International  
Aero Engines

V2500 Propulsion System — Nacelle

NACELLE - FIRE PROTECTION - FIRE DETECTOR ASSEMBLIES AND SUPPORT  
BRACKETS, ACCESSORY AND CORE - REPLACEMENT OF

V2500-NAC-26-0008

LEFT HAND ENGINE CORE ZONE FIRE DETECTOR ASSEMBLY  
FIGURE 1

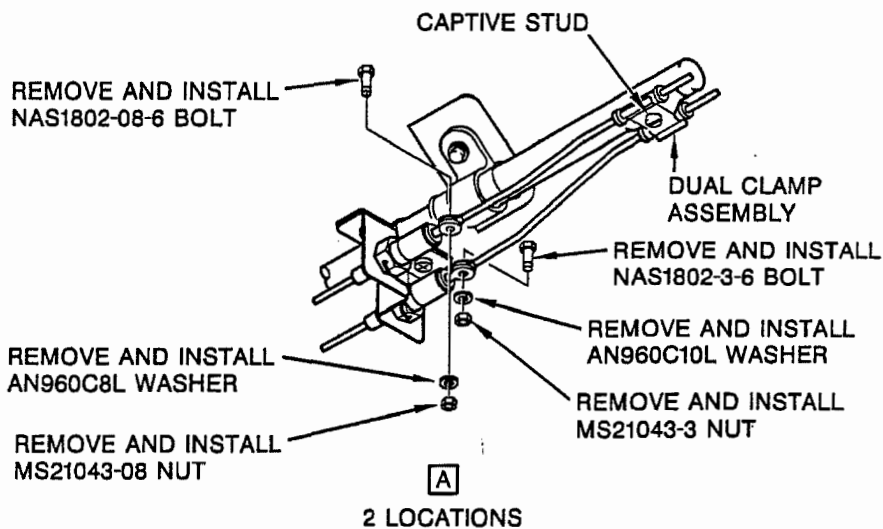
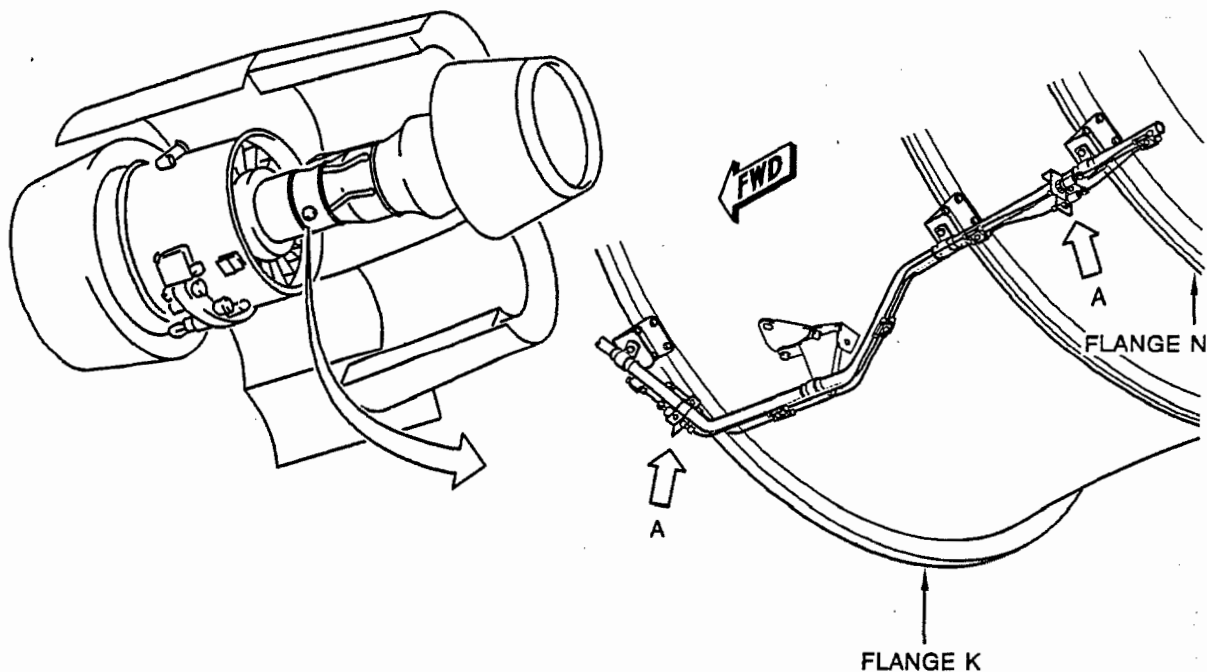
- (2) Remove the MS21043-08 and MS21043-3 nuts and AN960C8L and AN960C10L washers from the NAS1802-08-6 and NAS1802-3-6 bolts connecting the electrical harness wires to the fire detector. Remove the NAS1802-08-6 and NAS1802-3-6 bolts from the fire detector terminal lugs, and the terminal lugs on the electrical harness wires at two positions. See Figure 1.
- (3) Use a slotted screwdriver to apply pressure to the captive stud and rotate it counterclockwise one-quarter turn to release the clamp. This will free the electrical harness wires.
- (4) Remove and retain the MS9556-06 bolts, the C10GT3-08 clampbands and the C10GT3-08 clampshells from the four locations attaching the core zone fire detector to the engine. See Figure 2.
- (5) Remove the 290-5132-511 fire detector assembly from the engine.

- (16) Push the NAS1802-08-6 and NAS1802-3-6 bolts through the terminal lugs on the electrical harness wires and the sensor terminal lugs. Install the AN960C8L and AN960C10L washers and the MS21043-08 and MS21043-3 nuts on the bolts. Refer to Figure 1.
- (17) Torque the MS21043-08 and MS21043-3 nuts to 50-70 in-lb (5.6-7.8 Nm.).
- (18) Remove left hand engine accessory zone fire detector assembly as follows:
  - (a) Remove the MS21043-08 and MS21043-3 nuts and AN960C8L and AN960C10L washers from the NAS1802-08-6 and NAS1802-3-6 bolts connecting the electrical harness wires to the fire detector. Remove the NAS1802-08-6 and NAS1802-3-6 bolts from the fire detector terminal lugs, and the terminal lugs on the electrical harness wires at two positions. Retain attach hardware. Refer to Figure 6.

LEFT HAND ENGINE CORE ZONE FIRE DETECTOR ASSEMBLY  
FIGURE 3

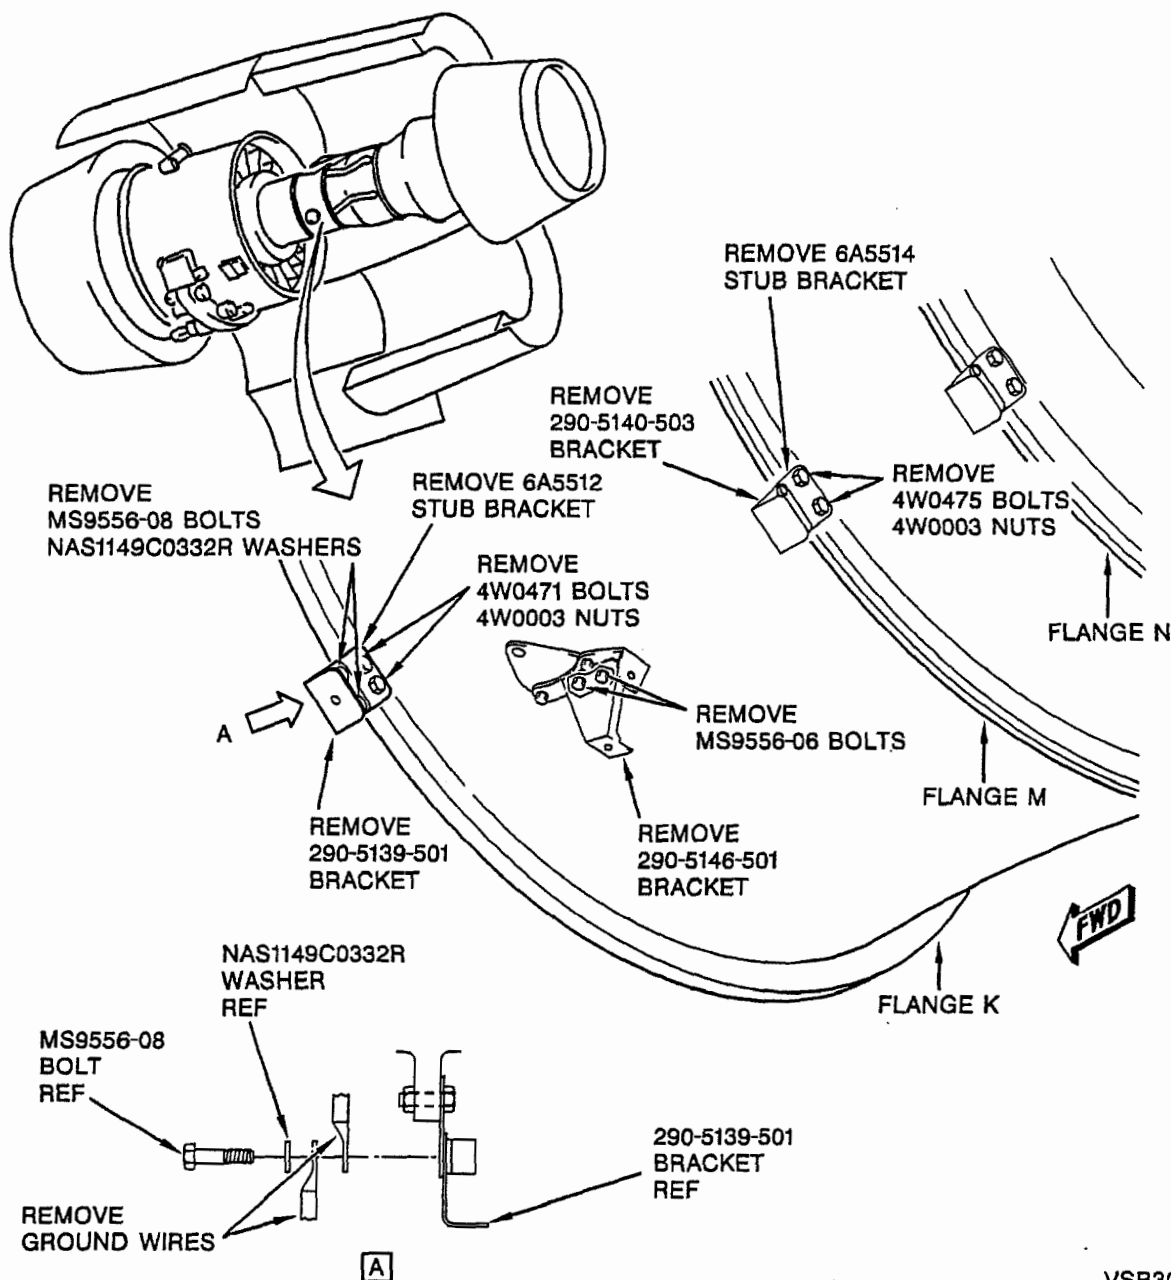
- (6) Remove and retain two MS9556-08 bolts and two NAS1149C0332R washers which attach ground wires and 290-5139-501 bracket to 6A5512 stub bracket on flange K. Discard 290-5139-501 bracket. Refer to Figure 3.

- (7) Remove and retain two 4W0471 bolts and two 4W0003 nuts from 6A5512 stub bracket on flange K. Discard stub bracket.
- (8) Remove and retain two MS9556-06 bolts which attach 290-5146-501 bracket to engine bracket. Discard bracket.

- (9) Remove and retain two 4W0475 bolts and two 4W0003 nuts which attach 6A5514 stub bracket and 290-5140-503 bracket to flange M. Discard two brackets.

LEFT HAND ENGINE CORE ZONE FIRE DETECTOR ASSEMBLY  
FIGURE 4

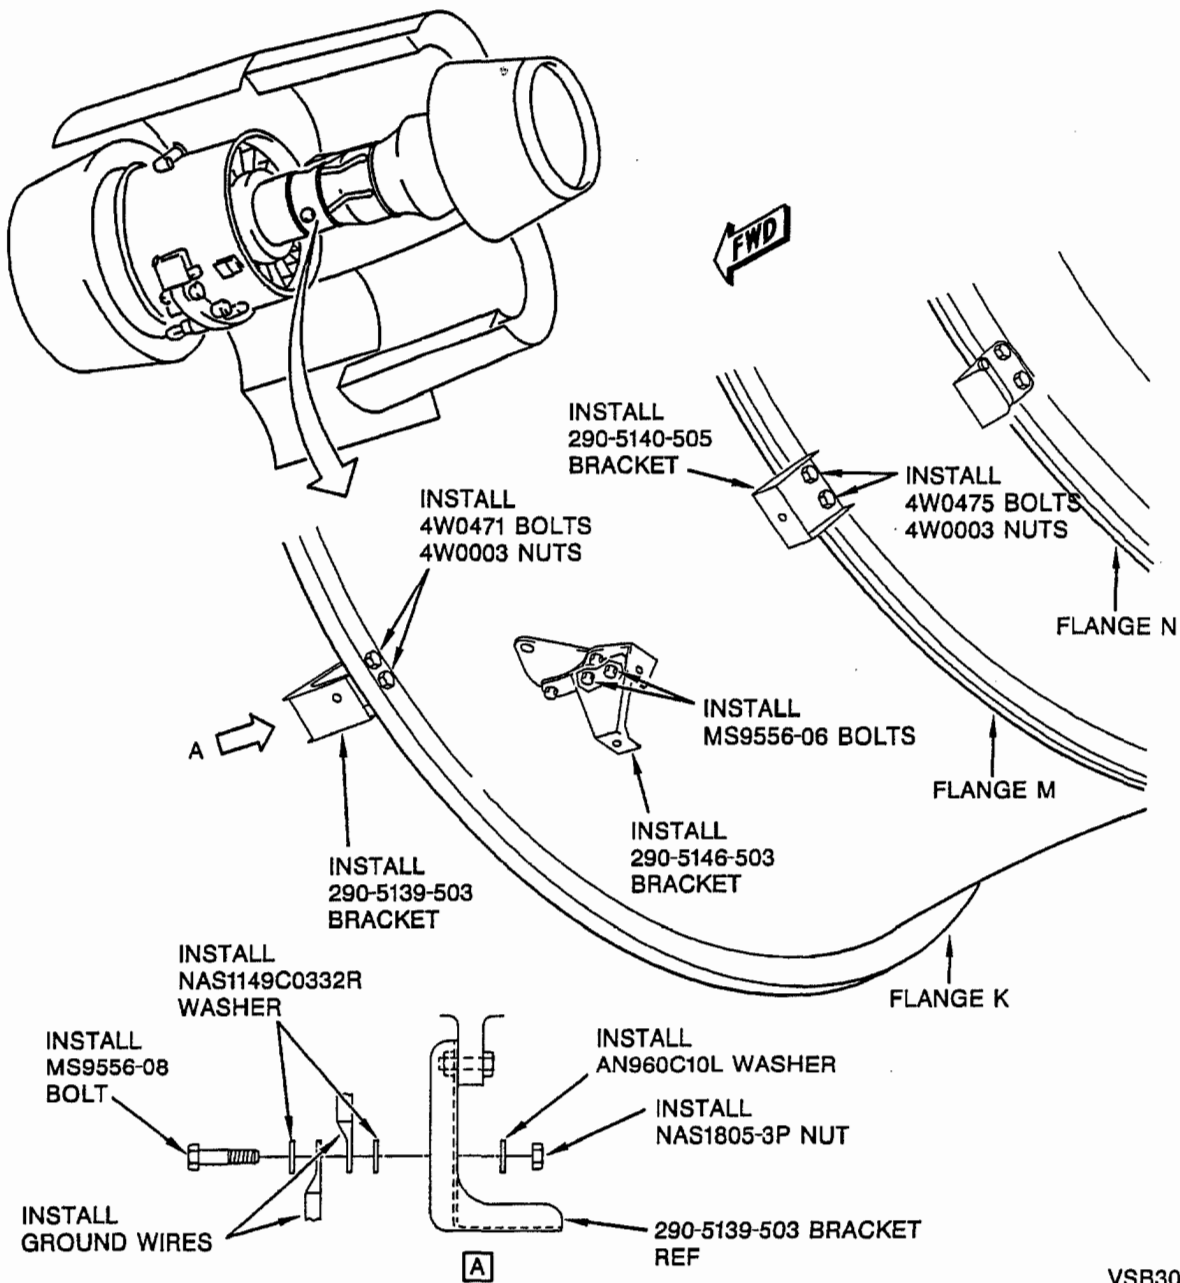
- (10) Install 290-5139-503 bracket on flange K with two 4W0471 bolts and two 4W0003 nuts. Tighten the nuts to a torque of 23-25 lbfin (3 Nm). Refer to Figure 4.

- (11) Attach ground wires to 290-5139-503 bracket with MS9556-08 bolt, AN960C10L washer, two NAS1149C0332R washers, and NAS1805-3P nut. Put ground wire terminals between two NAS1149C0332R washers on bolt head side of bracket.

- (12) Install 290-5146-503 bracket on engine bracket with two MS9556-06 bolts. Torque bolts to 23-25 in-lb (2.6-2.8 Nm.).
- (13) Install 290-5140-505 bracket on flange M with two 4W0475 bolts and two 4W0003 nuts. Torque bolts to 23-25 in-lb (2.6-2.8 Nm.).

LEFT HAND ENGINE CORE ZONE FIRE DETECTOR ASSEMBLY  
FIGURE 5

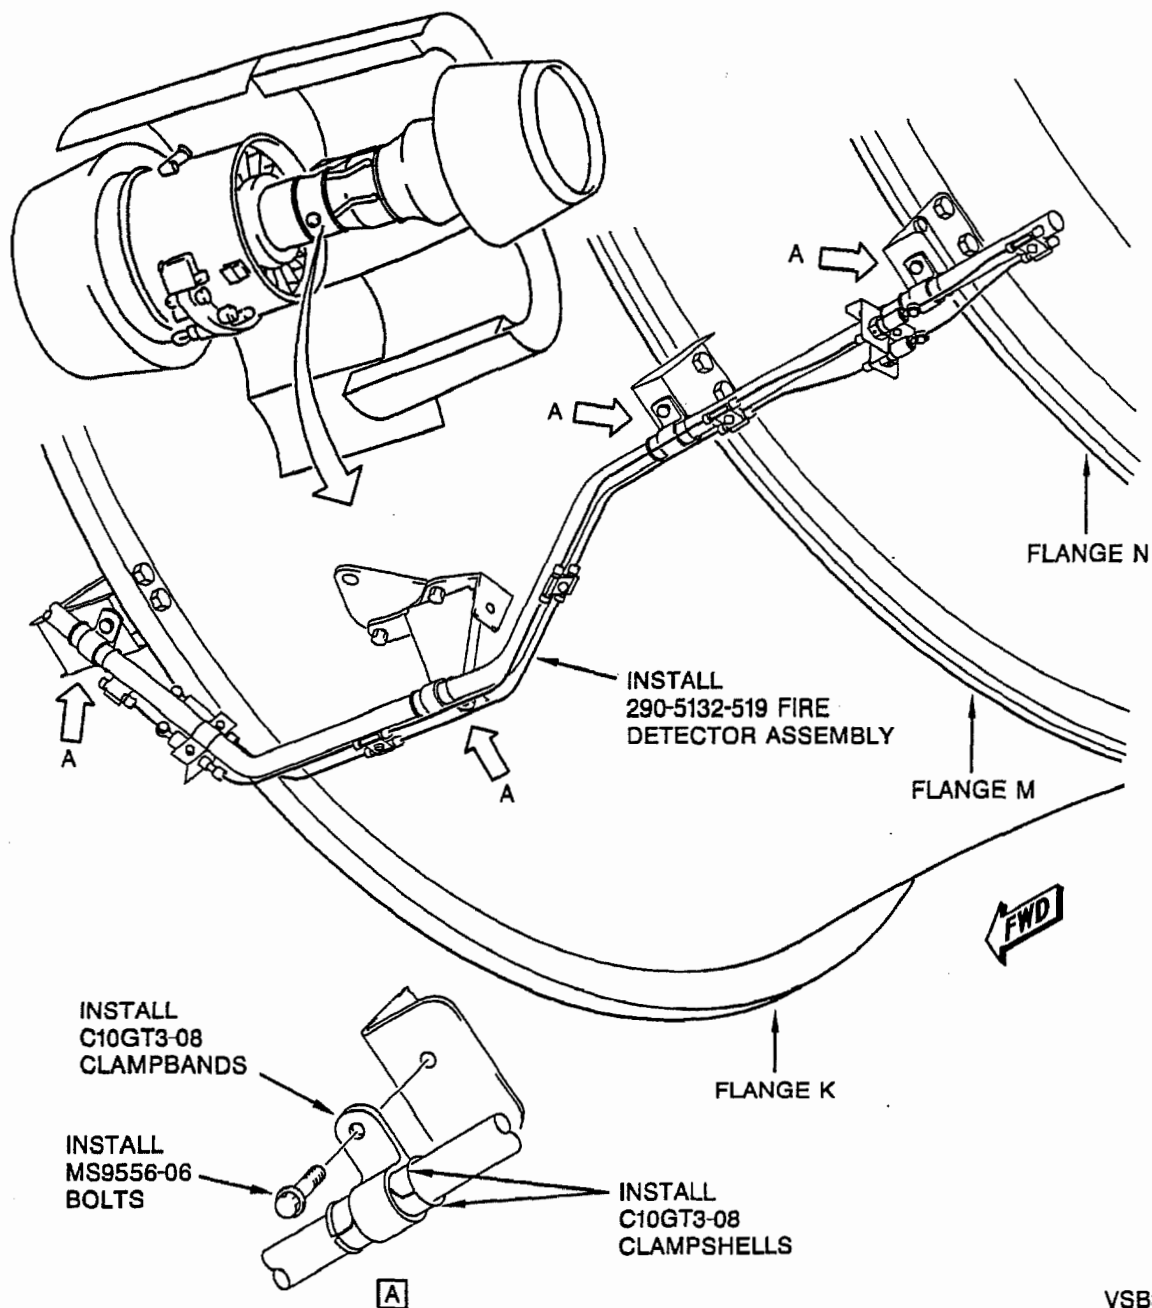
- (14) Put the 290-5132-519 fire detector assembly on the engine brackets with the four sets of retained C10GT3-08 clampshells, four C10GT3-08 clambands, and four MS9556-06 bolts. See Figure 5.

- (15) Torque the MS9556-06 bolts to 23-25 in-lb (2.6-2.8 Nm.).

LEFT HAND ENGINE ACCESSORY ZONE FIRE DETECTOR ASSEMBLY.  
FIGURE 7

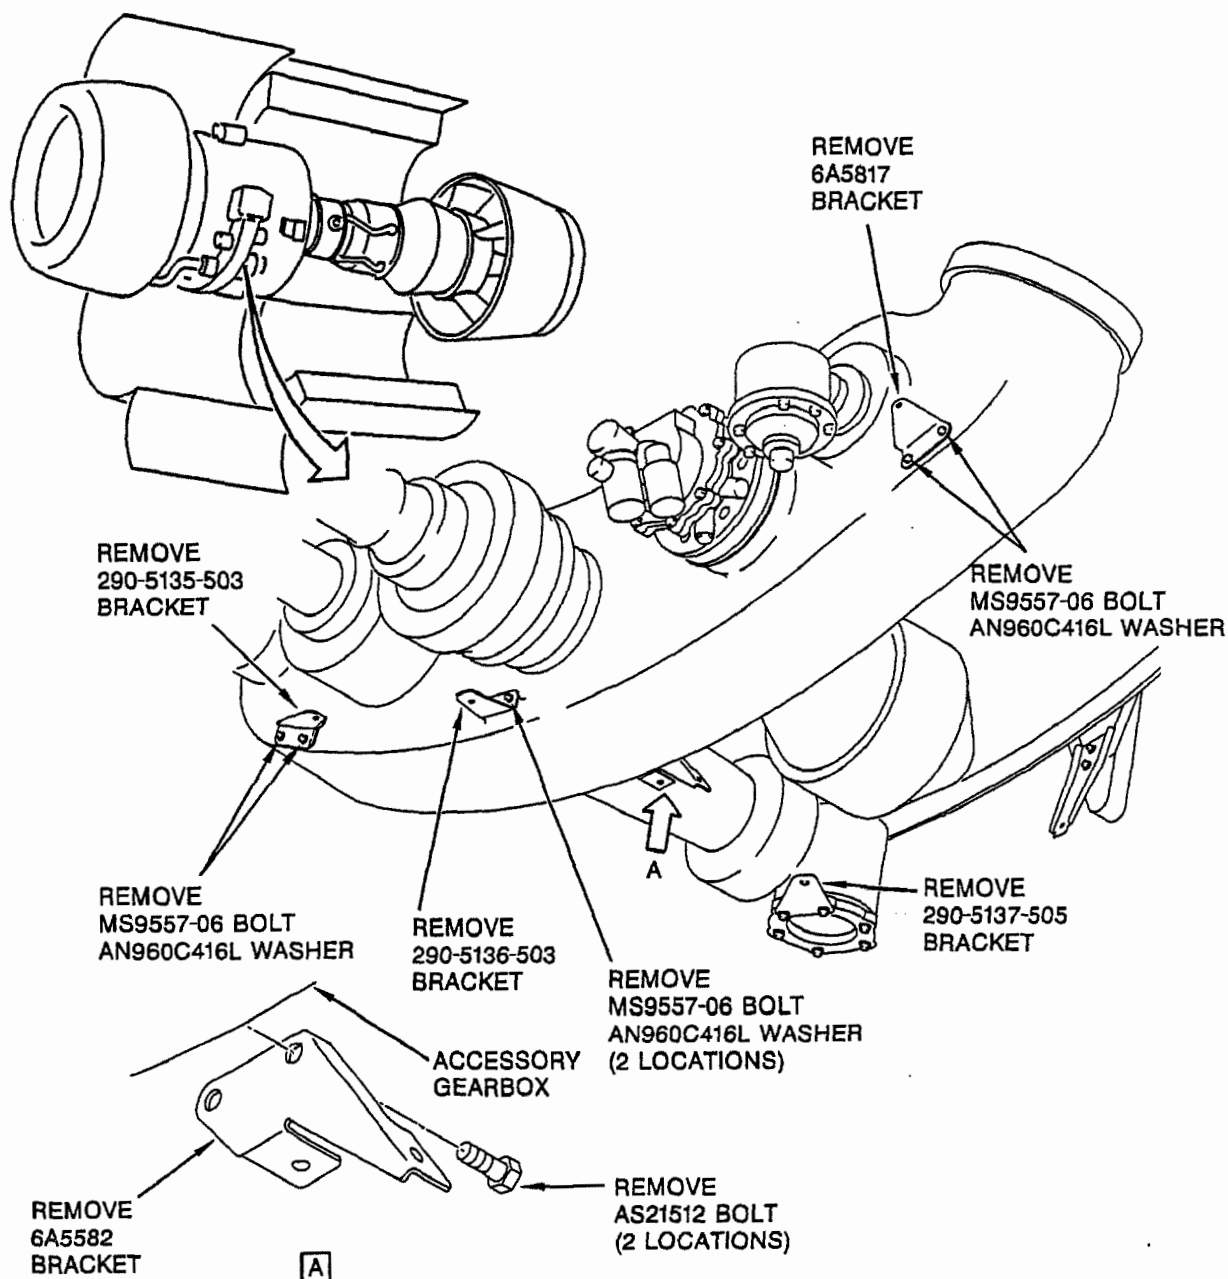
- (d) Remove the accessory zone fire detector assembly from the engine.
- (19) Remove two MS9557-06 bolts, two AN960C416L washers, and 290-5135-503 bracket from accessory gearbox. Retain bolts and washers. Discard bracket. See Figure 7.

- (20) Remove two MS9557-06 bolts, two AN960C416L washers, and 290-5136-503 bracket from accessory gearbox. Retain bolts and washers. Discard bracket.
- (21) Remove two MS9557-06 bolts, two AN960C416L washers, and 6A5817 bracket from accessory gearbox. Retain bolts and washers. Discard bracket.

- (22) Remove two AS21512 bolts and 6A5582 bracket from accessory gearbox bracket. Retain bolts. Discard bracket.
- (23) Remove two existing bolts, washers, and 290-5137-505 bracket from angle drive. Retain bolts and washers. Discard bracket.

FIGURE 8

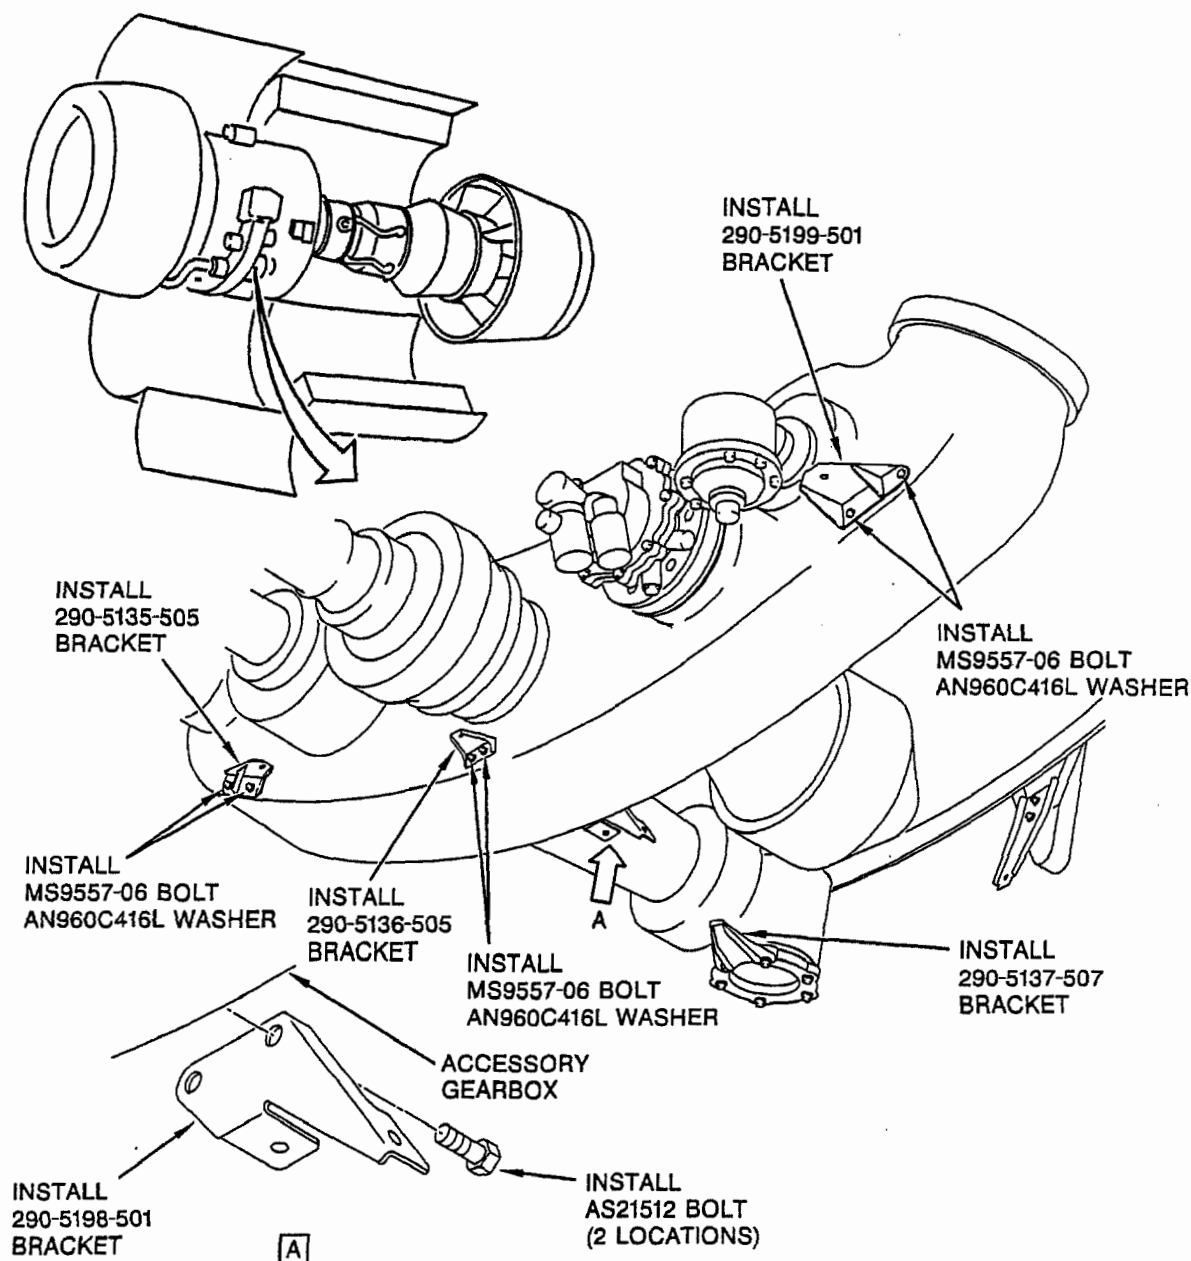
- (24) Install 290-5137-507 bracket to angle drive with existing bolts and washers. Tighten bolts to a torque of 63-70 in-lb (7.2-7.9 Nm.). Refer to Figure 8.

- (25) Install 290-5198-501 bracket to accessory gearbox with two AS21512 bolts. Tighten bolts to a torque of 63-70 in-lb (7.2-7.9 Nm.).
- (26) Install 290-5199-501 bracket to accessory gearbox with two MS9557-06 bolts and two AN960C416L washers. Torque bolts to 63-70 in-lb (7.2-7.9 Nm.).

- (27) Install 290-5136-505 bracket to accessory gearbox with two MS9557-06 bolts and two AN960C416L washers. Torque bolts to 63-70 in-lb (7.2-7.9 Nm.).

- (28) Install 290-5135-505 bracket to accessory gearbox with two MS9557-06 bolts and two AN960C416L washers. Torque bolts to 63-70 in-lb (7.2-7.9 Nm.).
